Supplement to the proposal for 02 series of amendments to Regulation No. 94

The text reproduced below was prepared by the expert from France in order to extend the scope of the present Regulation to all kinds of power train systems above a certain working voltage level. The modifications to the existing text of the Regulation R 94 are based on informal document No. GRSP- 46-04, distributed during the forty sixth session of the Working Party on Passive Safety (GRSP) and discussions made at the 3rd EVPC adhoc group meeting held in Bonn, 11-12 march 2010, respectively. This informal document supersedes document ECE/TRANS/WP.29/GRSP/2010/20 distributed as an official document for the forty-seventh session of the Working Party on Passive Safety (GRSP). The modifications to the existing text of Regulation No. 94 are originally marked in bold or strikethrough characters and the modifications resulting from the EVPC meeting are highlighted in grey colour.

Figure 3: Measurement of V'1

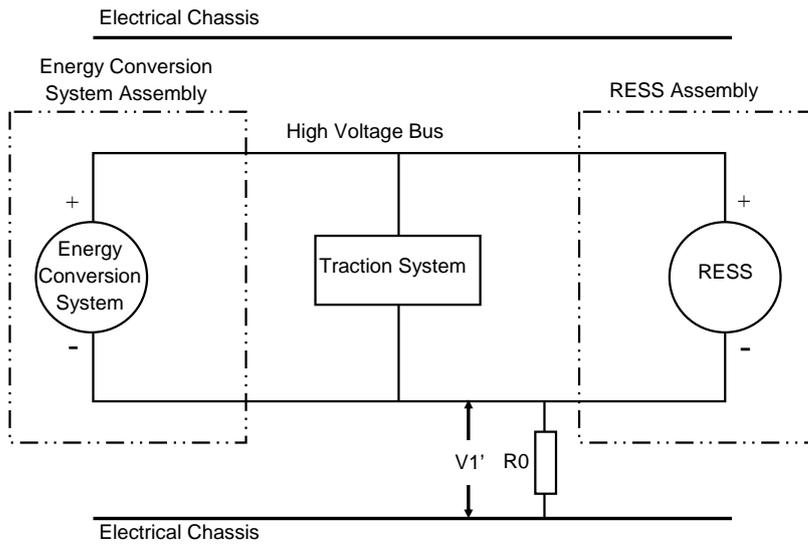
If V1 is greater than or equal to V2, insert a standard known resistance (Ro) between the negative side of the high voltage bus and the electrical chassis. With Ro installed, measure the voltage (V1') between the negative side of the high voltage bus and the vehicle electrical chassis (see figure 3). Calculate the isolation resistance (Ri) according to the formula shown below.

$$R_i = R_o * (V_b / V_1' - V_b / V_1) \quad \text{or} \quad R_i = R_o * V_b * (1 / V_1' - 1 / V_1)$$

Divide the result Ri, which is the ~~this~~ electrical isolation resistance value (in Ω), by the working voltage of the high voltage bus (~~in volts~~ Volt).

Figure 4: Measurement of V'2

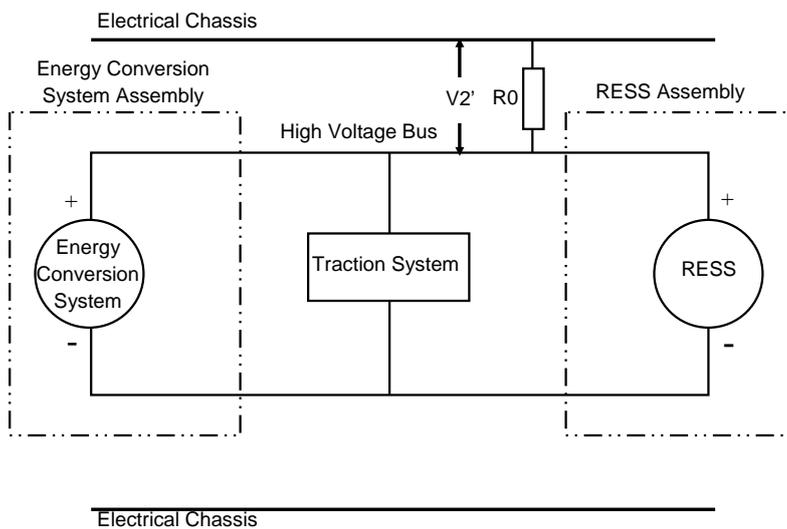
If V2 is greater than V1, insert a standard known resistance (R0) between the positive side of the high voltage bus and the electrical chassis. With R0 installed, measure the voltage (V2') between the positive side of the high voltage bus and the electrical chassis (see figure 4).

Calculate the isolation resistance (Ri) according to the formula shown below.

$$R_i = R_0 * (V_b / V_2' - V_b / V_2) \quad \text{or} \quad R_i = R_0 * V_b * (1 / V_2' - 1 / V_2)$$

Divide the result Ri, which is the electrical isolation resistance value (in Ω), by the working voltage of the high voltage bus (in volts).

Figure 1: Jointed test finger

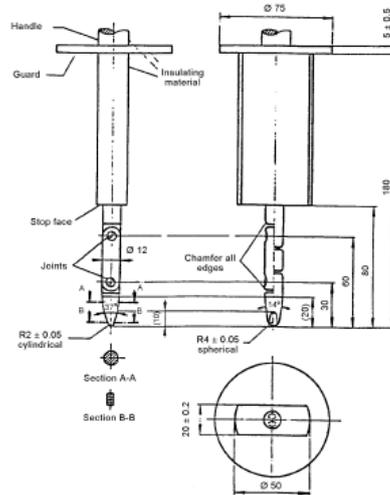
The Jointed Test Finger ~~access probe~~ described in Appendix 1 figure 1 ~~is pushed against~~ shall be inserted into any gaps or openings of the ~~original~~ physical protection with a ~~the~~ test force of $10\text{ N} \pm 10\text{ per cent}$ for electrical safety assessment. If partial or full penetration ~~it partly or fully penetrates into the original physical protection~~ by the Jointed Test Finger occurs, ~~it is~~ the Jointed Test Finger shall be placed in every possible position as specified below.

Starting from the straight position, both joints of the test finger shall be rotated progressively ~~successively bent~~ through an angle of up to 90 degrees with respect to the axis of the adjoining section of the finger and shall be placed in every possible position.

The requirements of paragraph 5.2.8.1.3 shall be considered to be met if the Jointed Test Finger ~~access probe~~ described in Appendix 1, figure 1 ~~shall not~~ is unable to contact high voltage ~~touch~~ live parts.
